Access Compliance Report

Public Rights-of-Way

Intersection ID: 13936	Main Street: S_KINGS_DR	Cross Street: CHARLOTTETOWNE_AV	Location: SW
ADA ID: BAD7AC35A499	Ramp Type: Perp	Initial Pass/Fail: Fail	Overall Compliance: No
		Severity Score: 25

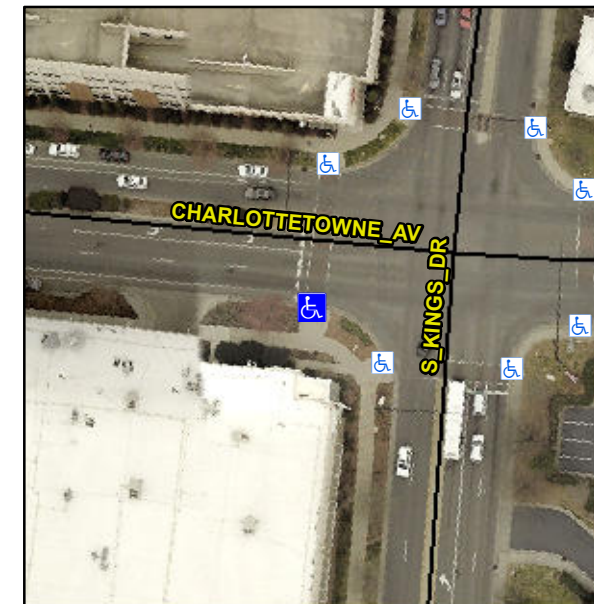
Not Found, R304.5.3

Compliance	Description	Data	Compliance	Description	Data
N/A	Ramp Length (in)	48.0	Yes	Ramp Slope (%)	5.4
Yes	Ramp Width (in)	48.0	No	Ramp XSlope (%)	7.1
N/A	Flare Type LT	N/A	N/A	Flare Type RT	N/A
N/A	Flare Slope LT (%)	N/A	N/A	Flare Slope RT (%)	N/A
N/A	Flare Traversable LT?	N/A	N/A	Flare Traversable RT?	N/A
N/A	Landing Length (in)	N/A	N/A	DWS Provided?	N/A
N/A	Landing Width (in)	N/A	N/A	DWS Contrast?	N/A
N/A	Landing Slope (%)	N/A	N/A	DWS Length (in)	N/A
N/A	Landing X Slope (%)	N/A	N/A	DWS Full Width?	N/A
N/A	Landing Curb? (Y/N)	N/A	N/A	DWS Offset (in)	N/A
N/A	Shared Landing?	N/A			
N/A	Gutter Ponding?	N/A	N/A	Gutter Slope (%)	N/A
N/A	Gutter Lip Ht (in)	N/A	N/A	Gutter X Slope (%)	N/A
N/A	Painted X Walk1?	Yes	N/A	Painted X Walk2?	N/A
	X Walk 1 Direction	To N		X Walk 2 Direction	N/A
N/A	X Walk 1 Width (in)	111.0	N/A	X Walk 2 Width (in)	N/A
	X Walk 1 Slope (%)	0.1		X Walk 2 Slope (%)	N/A
	X Walk 1 X Slope (%)	5.0		X Walk 2 X Slope (%)	N/A

Remove & Replace Entire Ramp.
